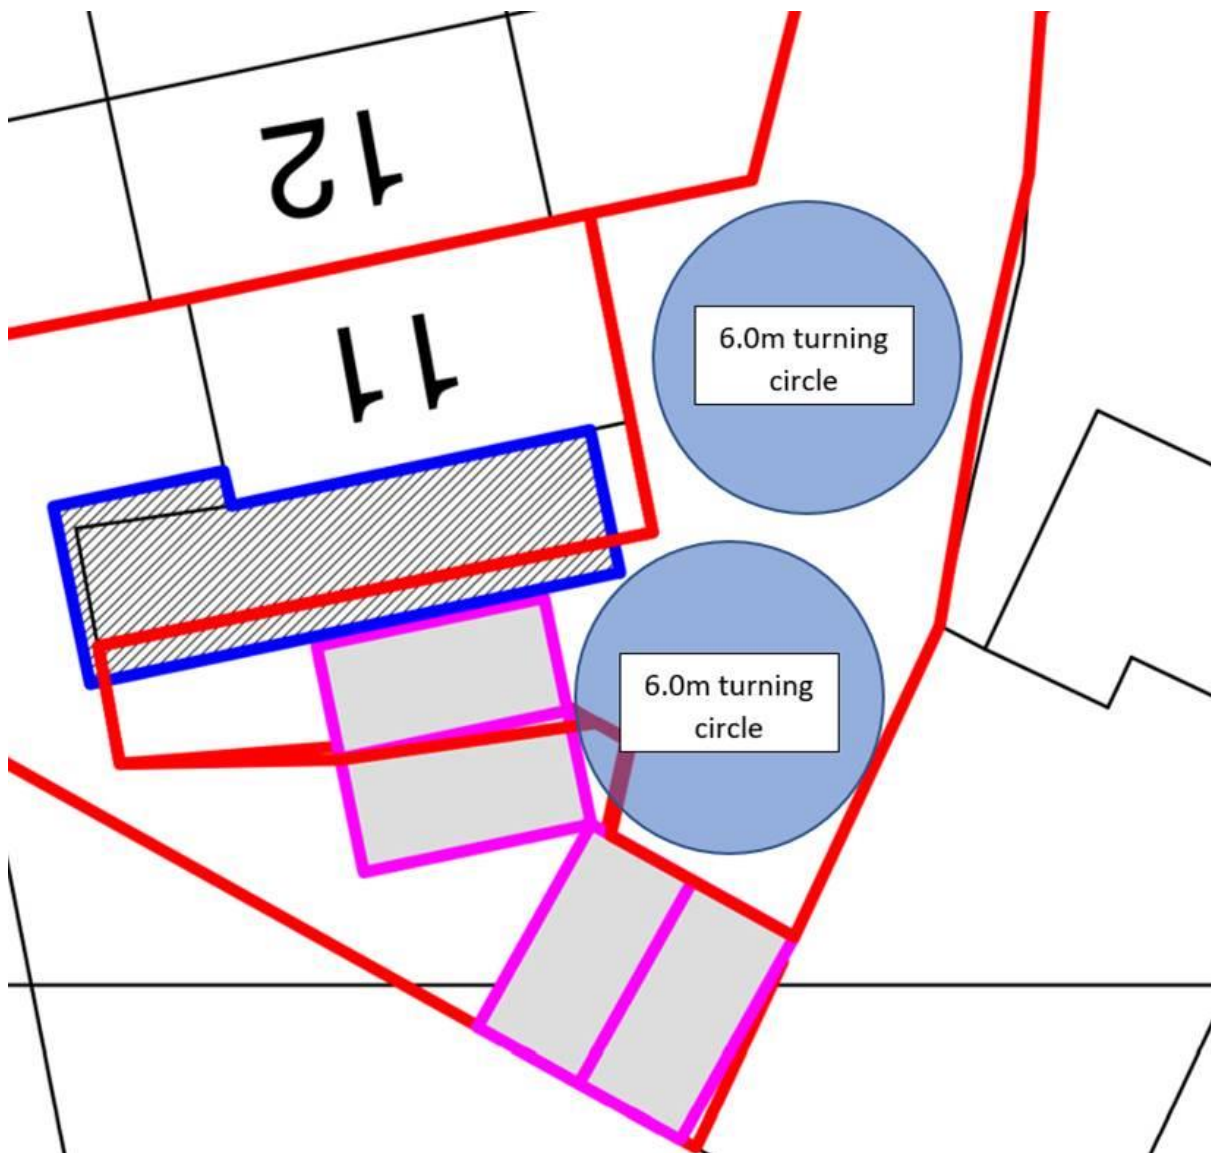
Looking at the plans, it would appear that there would be an adequate 6.0m turning circle both directly adjacent to the property, and also a secondary option to the front of the property, though plans do not make clear if this will be driveway (hard surfacing) or front garden (landscaping).

As such, in terms of usability, I would have no concerns.
